**From:** [Renah Givney](#)  
**To:** [Michelle Niles](#)  
**Cc:** [Tim Smith](#)  
**Subject:** SSD-22536006 - Pacific Bay Resort Studios & Village - Lots 5, 6 and 7 DP 1112654 and SP53080 - Resort Drive, Coffs Harbour  
**Date:** Tuesday, 10 August 2021 11:53:16 AM  
**Attachments:** [image001.png](#)  
[image002.jpg](#)

Council has reviewed the documents described as 'Scoping Report for SEARs', 'Concept Architectural Drawings' and Transport for NSW's response to the SEARs (letter from TfNSW dated 6 July 2021 – ref NTH21/00147/01). The following comments are provided for your consideration:

## BUS STOP CONSIDERATIONS

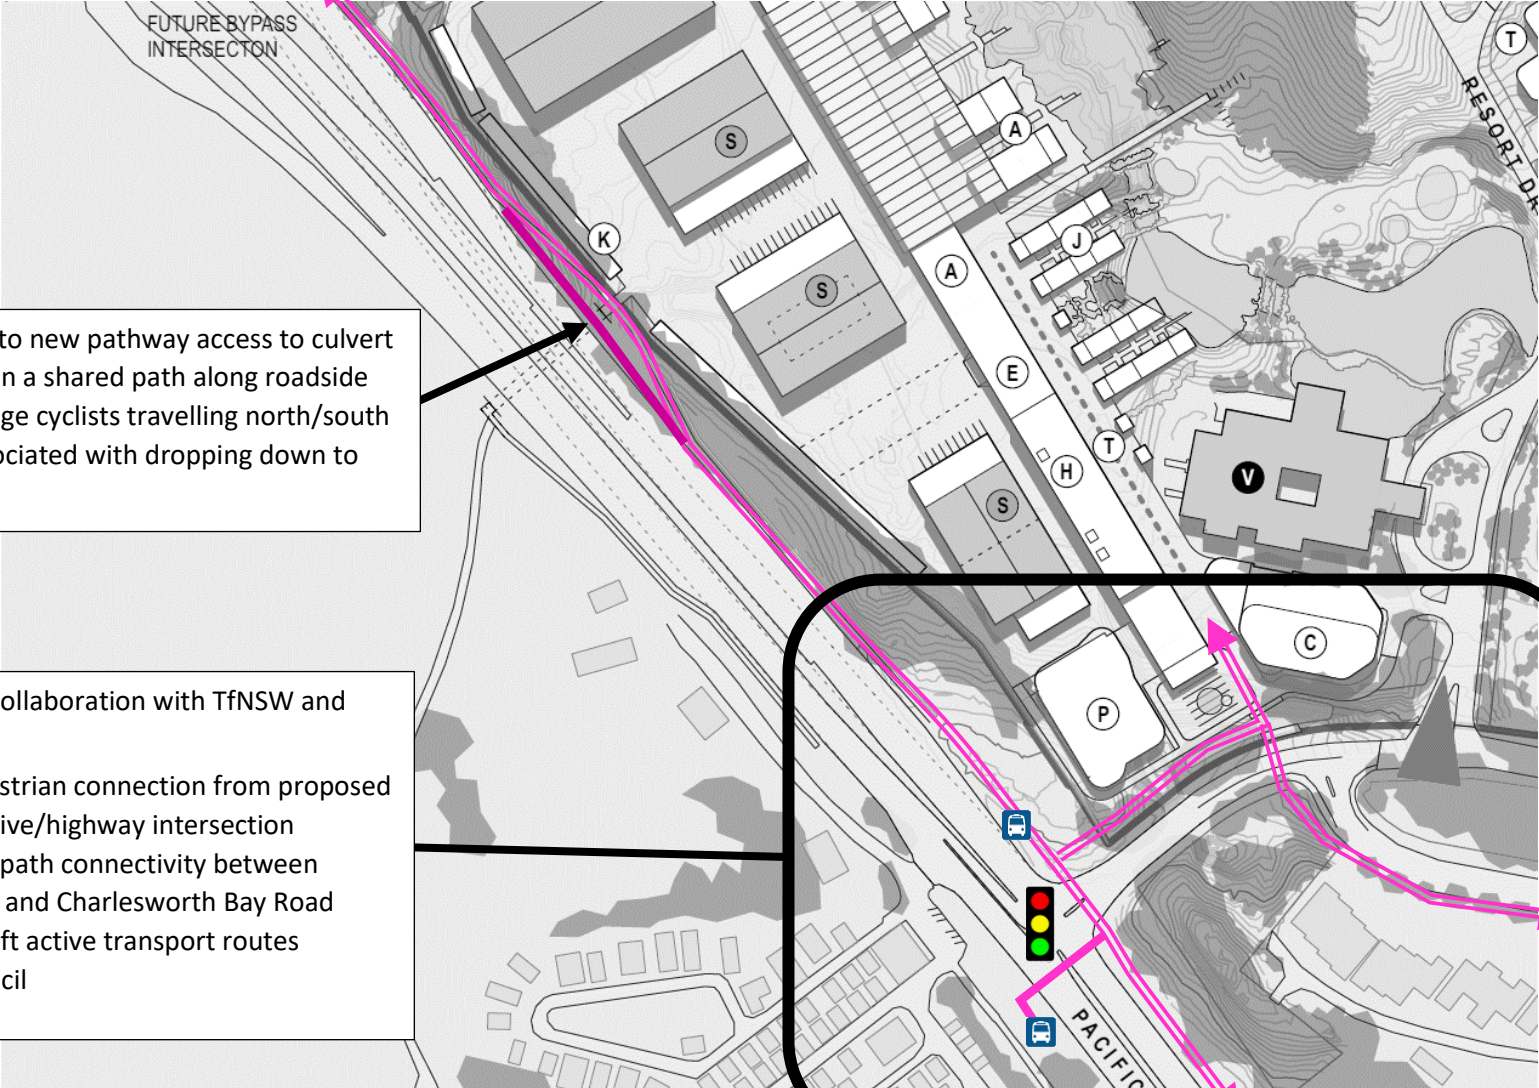
- Specific comments regarding pathway concepts shown on Concept Architectural Drawings:
  - **Bus stops:** The on-site employment potential of the development would make this location a key stop on north-south trunk bus routes. The proposed signalised intersection of Bay Drive and the existing highway as part of the Coffs Harbour bypass project creates the opportunity for bus stops with safe and direct pedestrian connection to the site. Therefore, it is recommended that a collaborative approach is undertaken with TfNSW and Council in regard to both the provision of bus stops near the intersection of the existing highway and Bay

Drive (refer to 'BUS STOP CONSIDERATIONS' in Attachment A) and the pedestrian connection along the Bay Drive entry in combination with the Coffs Harbour bypass project.

## PATH NETWORK CONSIDERATIONS - 1

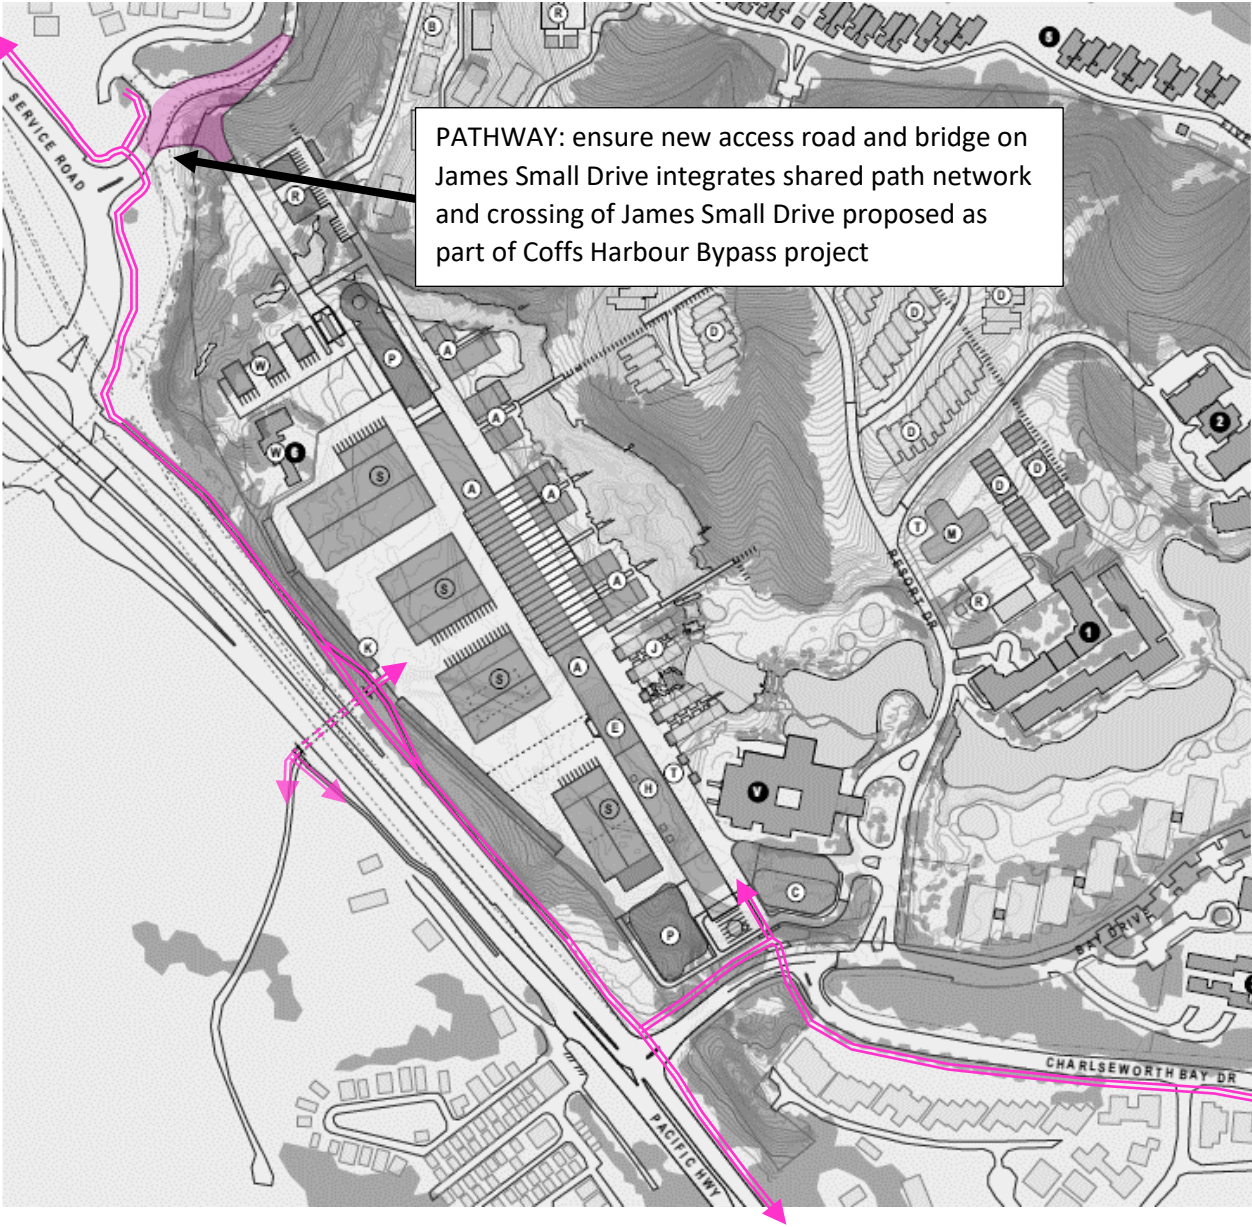
- **Pathway alignment to provide access via culvert underpass of highway:** This concept is supported to assist with active travel to the site (particularly for cyclists). However, it is also recommended that the shared path proposed as part of the Coffs Harbour bypass project also continues alongside the highway (in addition to the path dropping down to the underpass) so as not to disadvantage cyclists travelling north-south past the development site with unnecessary grade changes (ie so they don't have to ride up a hill from the underpass unnecessarily) – refer to 'PATH NETWORK CONSIDERATIONS – 1' in Attachment A;

- **Bay Drive entry enhancements:** in collaboration with TfNSW and Council provide: continuous shared path connectivity between highway, Bay Drive and Charlesworth Bay Road consistent with draft active transport routes developed by Council; and easy and safe pedestrian connection from proposed bus stops at Bay Drive/highway intersection. Refer to 'PATH NETWORK CONSIDERATIONS – 1' in Attachment A;

PATHWAY: in addition to new pathway access to culvert underpass also maintain a shared path along roadside so as not to disadvantage cyclists travelling north/south with grade change associated with dropping down to underpass

BAY DRIVE ENTRY: in collaboration with TfNSW and Council provide:

- easy and safe pedestrian connection from proposed bus stops at Bay Drive/highway intersection
- continuous shared path connectivity between highway, Bay Drive and Charlesworth Bay Road consistent with draft active transport routes developed by Council

PATH NETWORK CONSIDERATIONS - 2

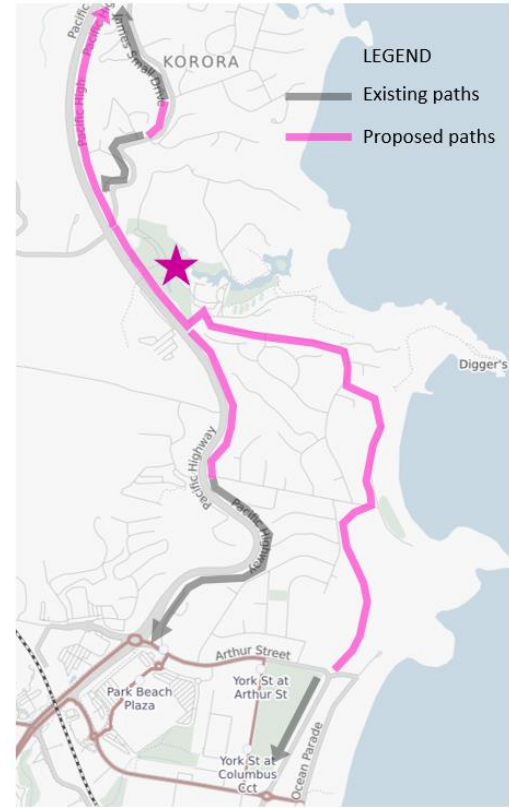
- **James Small Drive entry:** ensure new access road and bridge on James Small Drive integrates shared path network and crossing of James Small Drive proposed as part of Coffs Harbour Bypass project. Refer to 'PATH NETWORK CONSIDERATIONS – 2' in Attachment A;
